Applic. No. 10/791,539
Amdt. dated November 9, 2005
Reply to Office action of August 9, 2005

Drawing Amendments

FIG. 2
~~Fig. 2~~

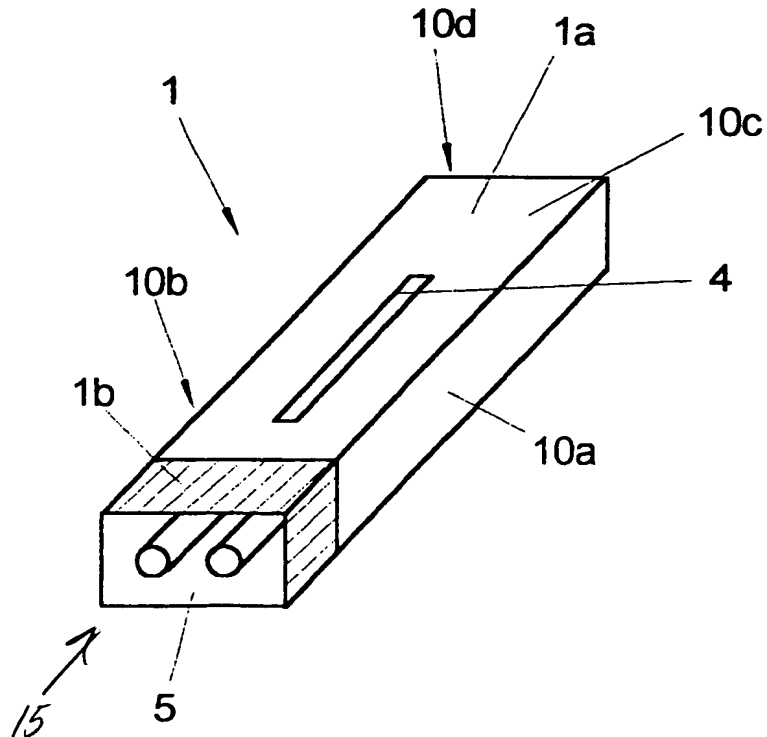
In the first paragraph on page 2 of the above-identified Office action, the drawings have been objected to under 37 CFR 1.83(a).

The Examiner has stated that the electrical component/transceiver must be shown or the feature cancelled from the claim. Figs. 2, 3, and 4 have been changed to include the reference numeral "15" directed to the optoelectronic component. Furthermore, the specification was amended to include the reference numeral "15". Therefore, the objection to the drawings by the Examiner is believed to have been overcome.

The attached sheets of drawings include changes to Figs. 2, 3, and 4. These sheets which include Figs. 1-4, replaces the original sheets including Figs. 1-4. In Figs. 2, 3, and 4, reference symbol "15" was added to indicate the optoelectronic component.

Please approve the drawing changes that are marked in red on the accompanying "Annotated Sheet Showing Changes" of Figs. 2, 3, and 4. Formal "Replacement Sheets" of amended Figs. 2, 3, and 4 are also enclosed.
